# APA FDR Answers To Committee Questions

B. Rebel, C. Touramanis, J. Evans

September 1, 2021

# APA temperature sensors

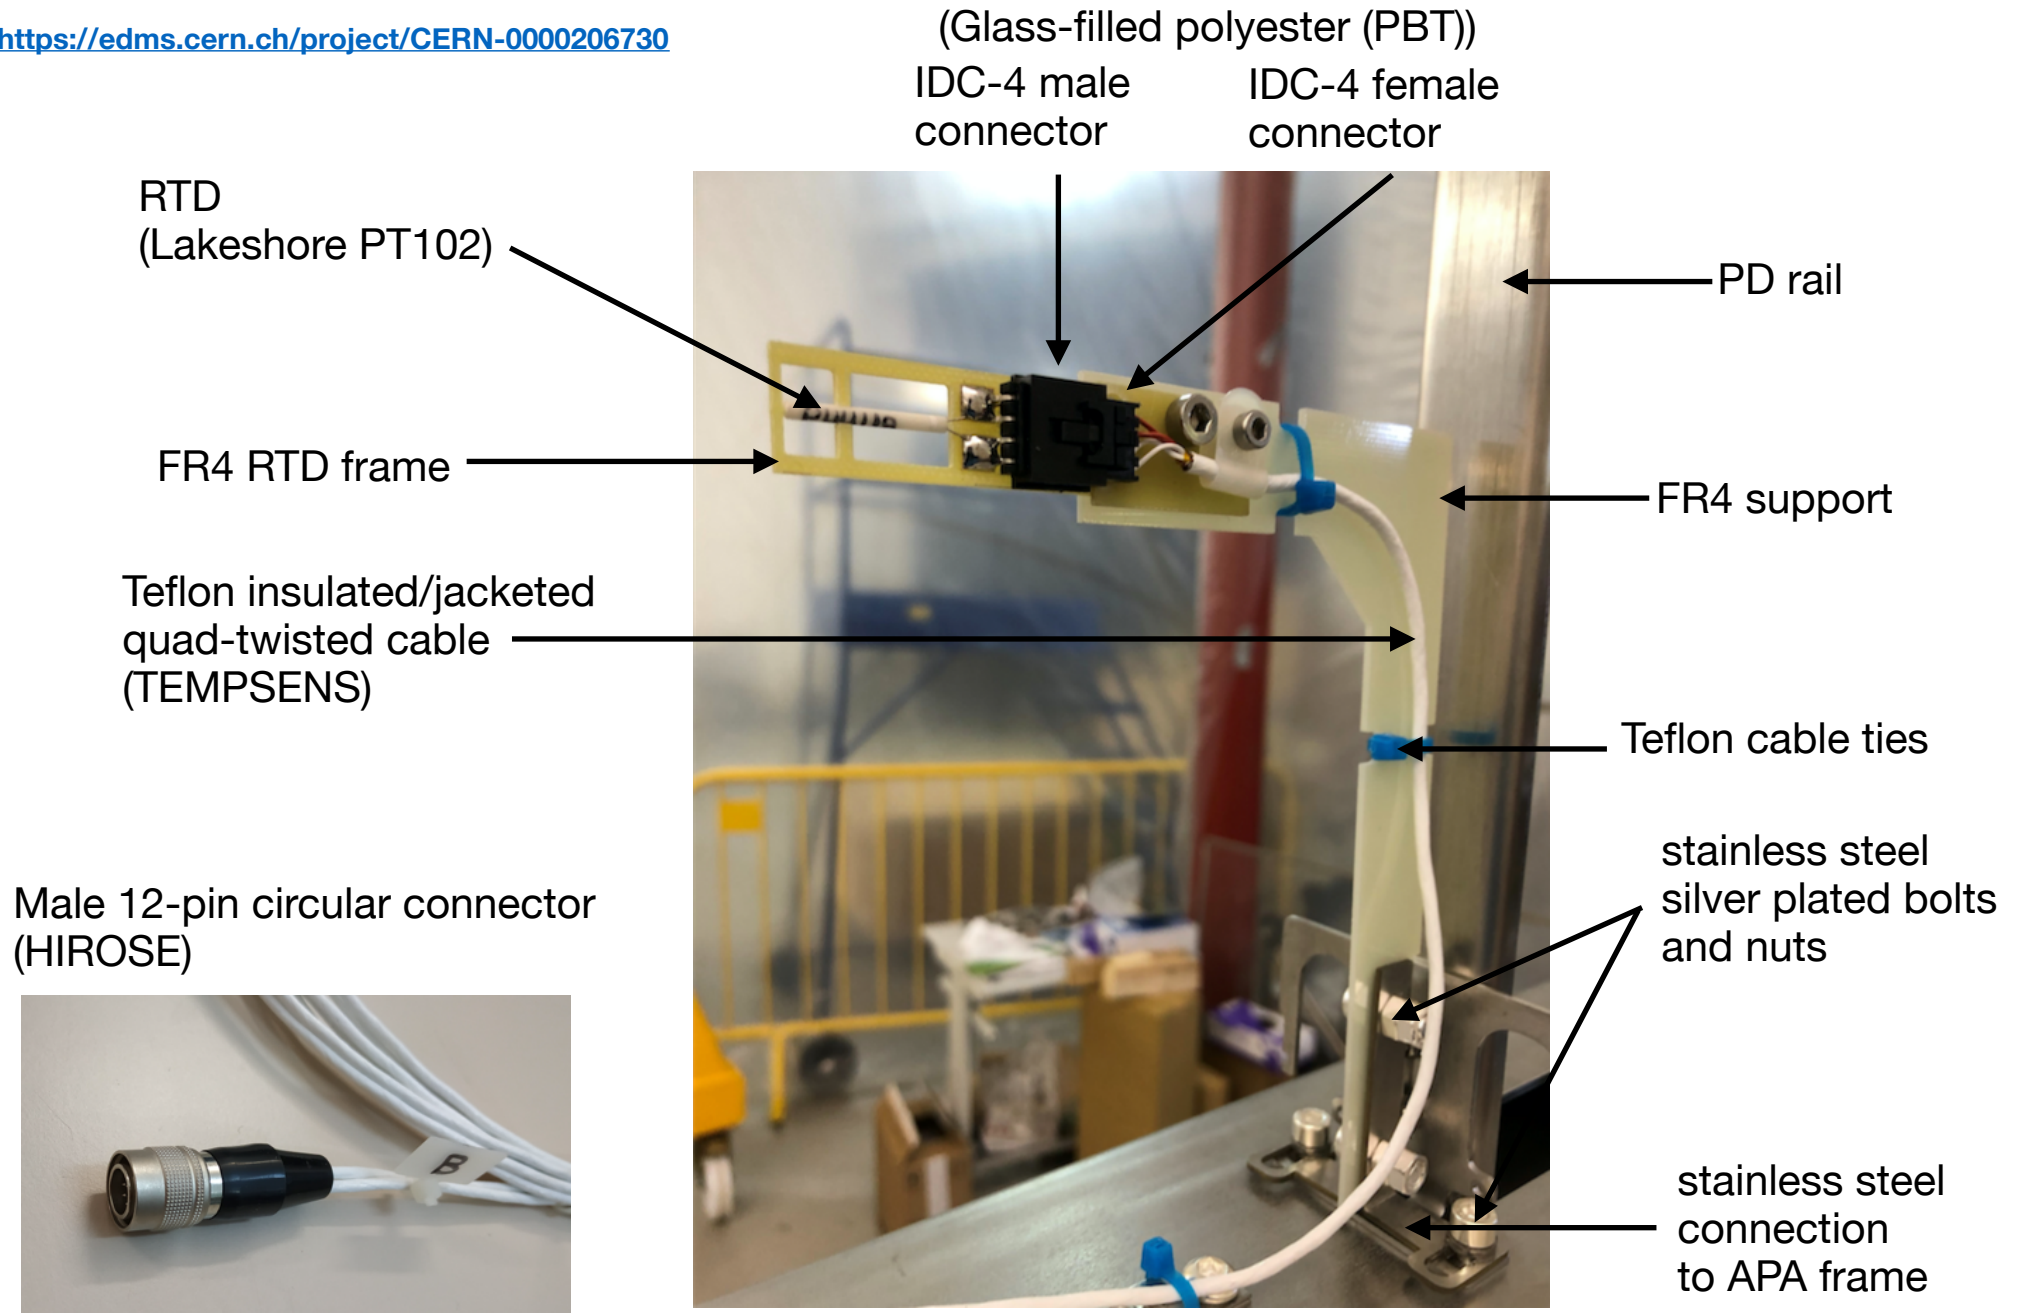
Can you please provide details for the RTD's including a bill of material, schematic, and justification for why specific things were chosen for the RTD's? (e.g. types of cables, the insulation, the connectors, etc...)

- The CALCI consortium is responsible for specifying these details of the RTDs, while the APA consortium is responsible for providing mounting points for the RTDs and real estate for the cable runs
- We agree that the concerns raised are important to address for the whole of DUNE to ensure stable operation of the detector
- ProtoDUNE experience showed that RTDs, either on the APA itself or anywhere inside the Cold Box, can introduce noise. As long as we can easily ground the whole RTD system externally we are safe.
- We contacted Anselmo Cervera to answer these questions

- Design choices:
  - Use photon detector cable routing and connectors
  - Number of sensors (4 per APA) limited by cable routing
  - Materials choice: Stainless steel, teflon and FR4
  - RTDs are decoupled from the rest (intermediate IDC-4 connectors) to allow precise calibration and avoid unnecessary manipulation during installation
  - Uninterrupted 1 mA DC current
  - quad-twisted cables with external EMC shielding individually grounded at flange and floating at sensor's end

# PD module connections

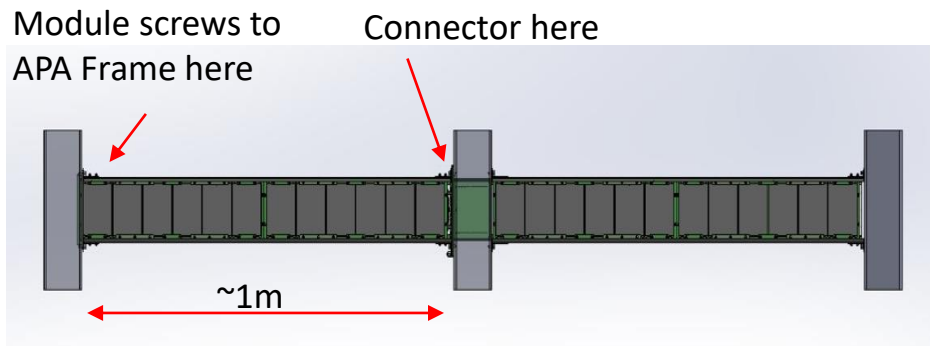
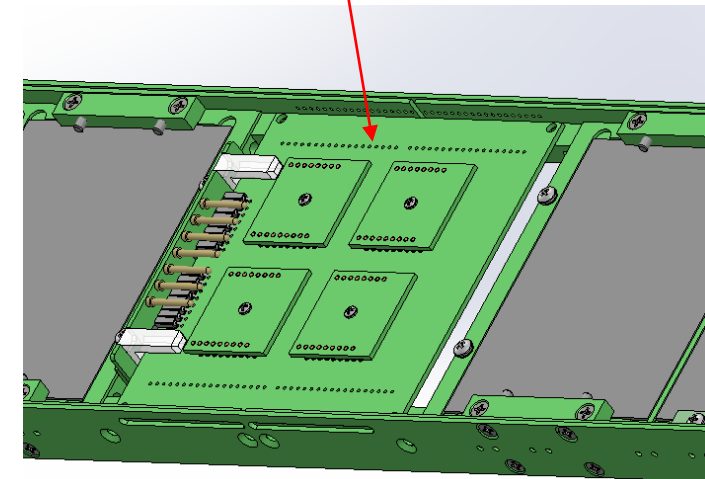
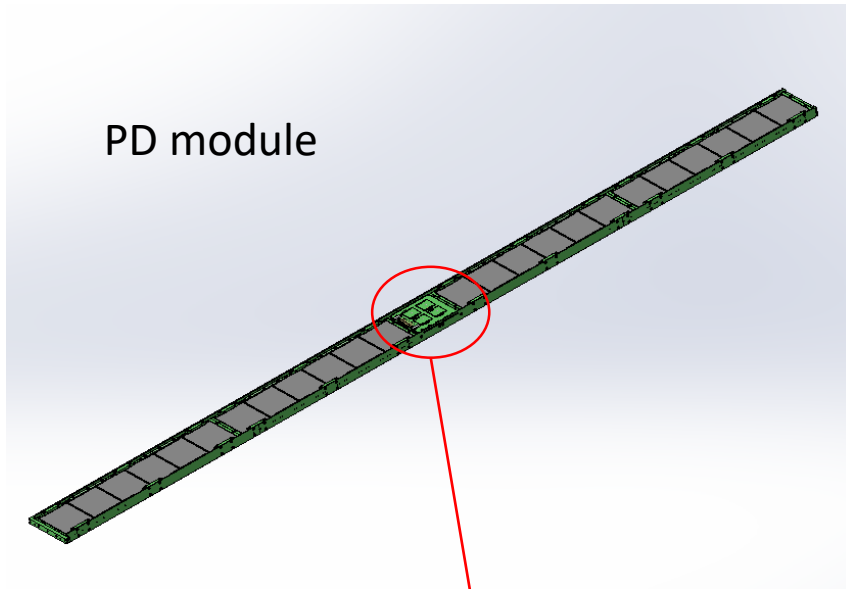
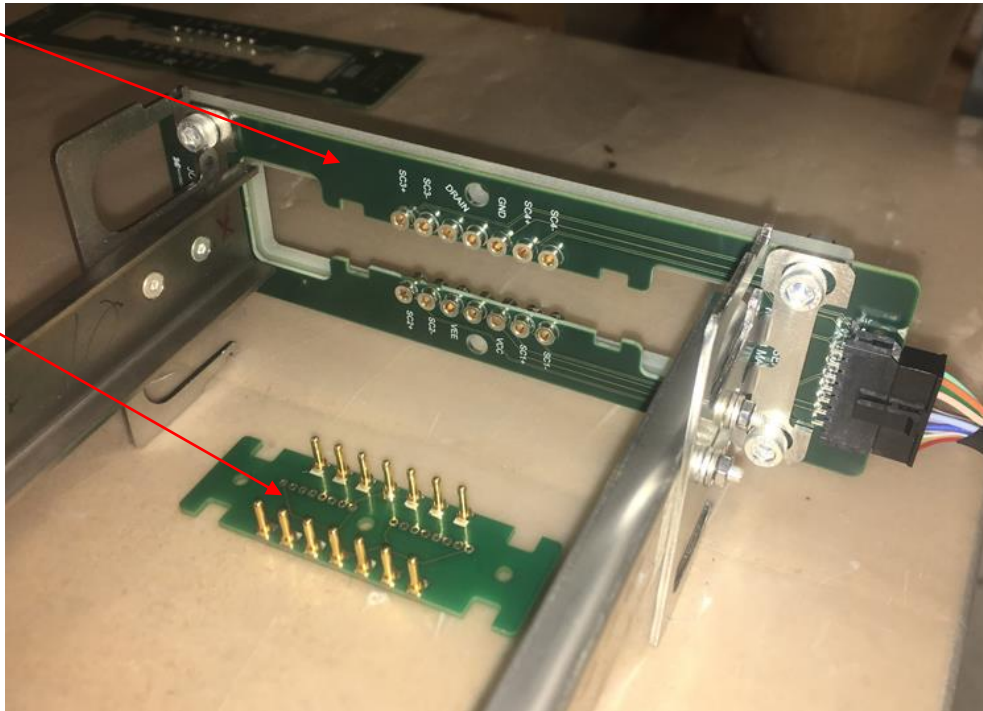
Q2: For the Photon Detectors (PD's) can you point us to documentation which shows how the PD cable is connected to the PD module, how the particular connector was chosen and how it was cold tested / stress tested?

Answer: The connection is described in general in the Photon Detector Cable Harness Rev. 6.20, which is included in the PD review documentation package. In general, mill-max pins mounted to a PCB attached to the PD module automatically mate to the sockets included in the connector board mounted to the APA during assembly. Connections went through multiple cryo tests at CSU, at PSL, and in Milano. See details in following slides.

n.b.: Relative thermal contraction of the module relative to the APA is small, but was addressed in the design.

Thermal contraction and tolerance buildup are addressed in the PD structural analysis note (Sec. 3.1) presented at the PDR (EDMS 2380229).
